Product Change Notice (PCN)

PCN Number: **PCN-0450972R-02**

Product(s) Affected: *SJ1-351XN Series. (SJ1-3513N, SJ1-3514N, SJ1-3515N)*

PREVIOUS CUI DEVICES DETAIL / IMAGE			NEW CUI DEVICES DETAIL / IMAGE

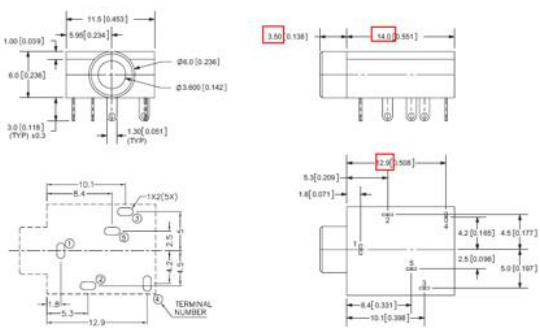
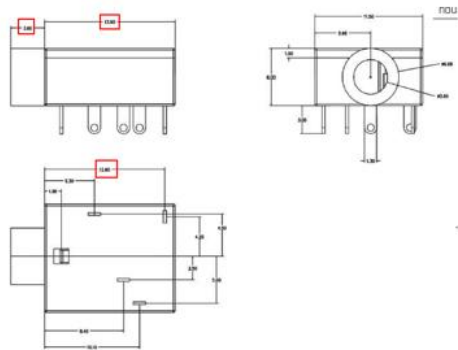
Reason(s) for Change: *Tooling and Material Change*

Description of Change: *Slight Dimensional difference. Terminal Material Change See image Below*

MATERIAL	PLATING	DESCRIPTION	MATERIAL	PLATING/COLOR
terminal 1	brass	silver	terminal 1	brass t=0.3	silver
terminal 2	brass	silver	terminal 2	phosphor bronze t=0.3	silver
terminal 3	brass	silver	terminal 3	brass t=0.3	silver
terminal 4	brass	silver	terminal 4	brass t=0.3	silver
terminal 5	brass	silver	terminal 5	phosphor bronze t=0.3	silver
bushing	brass	nickel	bushing	brass	nickel
spring	stainless steel		spring	steel	black
cover	PBT		cover	PBT (UL94V-0)	black
plastic	PBT		housing	PBT (UL94V-0)	black
